Howard J. Feldman

November 30, 2011

**Ref.: Proposed Rulemaking – Oil and Gas Sector Regulations
Standards of Performance for New Stationary Sources: Oil and Natural Gas
Production and Natural Gas Transmission and Distribution;
National Emission Standards for Hazardous Air Pollutants from Oil and Natural
Gas Production Facilities; and
National Emission Standards for Hazardous Air Pollutants from Natural Gas
Transmission and Storage Facilities
(Docket ID No. EPA-HQ-OAR-2010-0505)**

Figure 16-1 Emissions (lb/bbl) vs. Separator Pressure (psi)

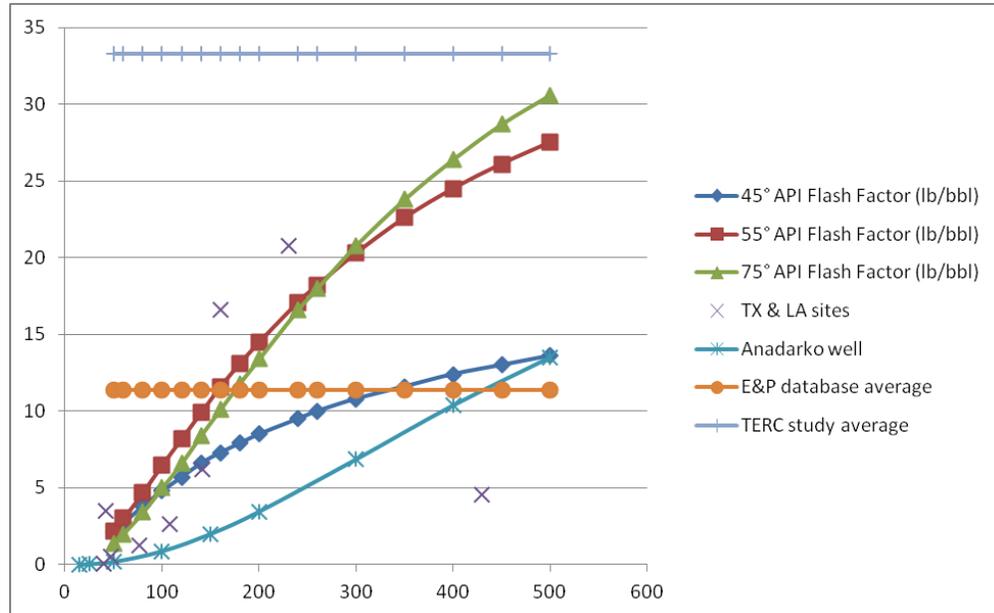
Figure 16-1 shows a graph of flashing emissions (in lb/bbl) as a function of separator pressure (in psi). This graph shows emissions estimated from three simulation methods. The results labeled "API Flash Factor" were obtained using ProMax^{DD} (includes two very volatile high API gravity condensates), the results labeled "TX & LA sites" were obtained using E&P TANK, and the results labeled "Anadarko well" were obtained using HYSYS^{EE}. For comparison, the TERC study average (33.3 lb/bbl) and the average of the E&P TANK Geographical Database Option with simulated results for 103 wells nationwide (11.4 lb/bbl) are also shown.

further suggests that it is not a credible value. However, as noted previously, a value of 14.9 lb/bbl is obtained from the TERC study when the most problematic data are removed from the data set. This value appears to be much more in line with simulation results using site-specific data. Also, the average value of 11.4 lb/bbl from the E&P TANK database falls reasonably within the simulation results. But the evident variability as a function of pressure shows that a simple average is not an appropriate indicator of flashing emissions.

A throughput-based factor for estimating flashing emissions should be expressed as a function of pressure drop, rather than applying a simple average value as a function of throughput. This could be done by means of a lookup table.

Figure 20-1. Process Flow for Produced Water To Evaporation Basins

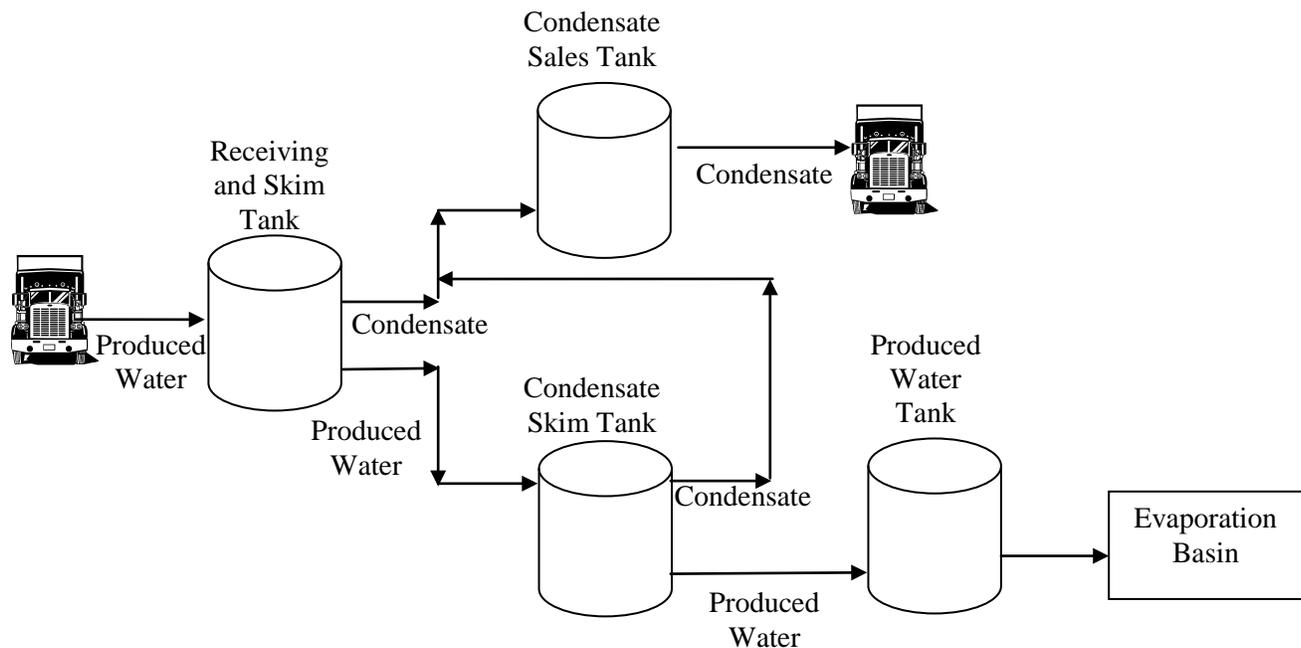
and they take extensive steps to prevent them. Typically, oil /condensate and water are separated initially at the wellhead with a three phase separator. Then the produced water enters a tank. Any oil or condensate entrained in the produced water then separates out in the produced water tank. Trucks are used to vacuum the oil or condensate from the top of the tank. The produced water is then trucked to the evaporation pond facility. There additional separation is done using a series of skim oil tanks as shown below. The produced water then enters the evaporation pond. Hydrocarbon emissions from the evaporation ponds are minimized since almost no separate phase hydrocarbon remains in the produced water placed into the evaporation ponds.

As far as estimating emissions, WATER9 is the only EPA approved method for calculating emissions from evaporation basins. The assumptions in this model are quite conservative and tend to overestimate emissions, not underestimate emissions. Assuming 100% of VOCs in the water enter the atmosphere is a completely false assumption that ignores the fate and transport of various chemicals. Many chemicals, like methanol, have a very high affinity for water and do not evaporate. Also, many chemicals, like methanol, can only be removed from water using biodegradation. EPA's "Measurement of Emissions from Produced Water Ponds: Upstream Oil and Gas Study #1"^{ZZ} found minimal emissions from the evaporation ponds.
